Revised 1/13/99 Destroy All Previous Copies

Applies To:

All Fusions equipped with carbon reinforced sprog assemblies.

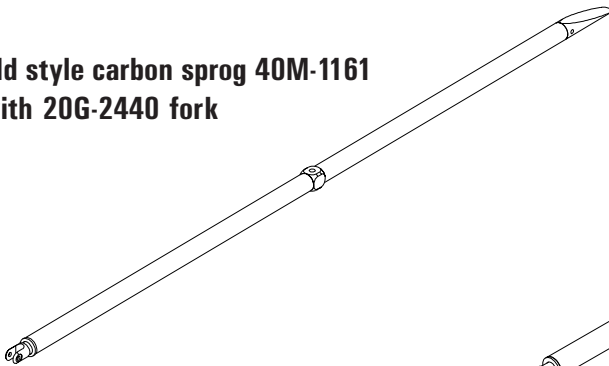
You must return both sides 40M-1161 SPROG ASSY - FUSION (everything shown in diagram 83E07 in your owners manual) to be eligible for warranty coverage.

**Old style carbon sprog 40M-1161
with 20G-2440 fork**

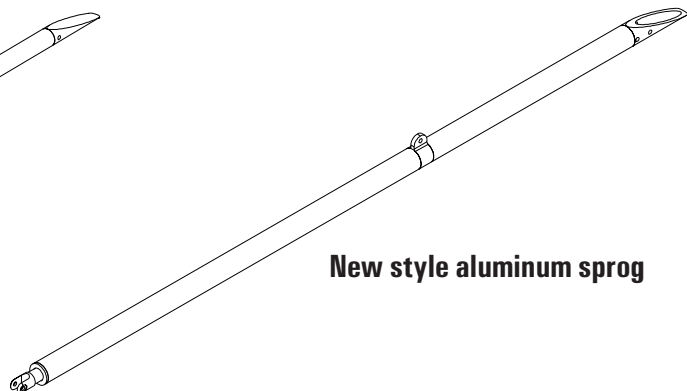
All Fusions manufactured after June of 1998 will be made with a new sprog design, utilizing a new, all 7075 aluminum tube, a new center fitting, a new rear paddle, a new cable, and a new threaded insert and stainless steel threaded fork. These parts, taken together as an assembly, with the addition of a longer bolt to mount the cable to the leading edge bracket, are backwards compatible with all earlier Fusions. In addition, the new threaded sprog fork is backwards compatible with the earlier carbon reinforced sprog tubes (if the original threaded insert is undamaged).

A sprog upgrade kit is available for \$75 retail per side and includes the parts listed in the first table below. By re-using those parts which are interchangeable from your old sprogs (listed in the second table) you can mount the new aluminum sprog assemblies. After mounting, the sprogs will need to be re-adjusted to the proper stability settings as specified in your manual, and a test flight to confirm proper adjustment is recommended. Any expense incurred for adjustment and/or test flight will be your responsibility.
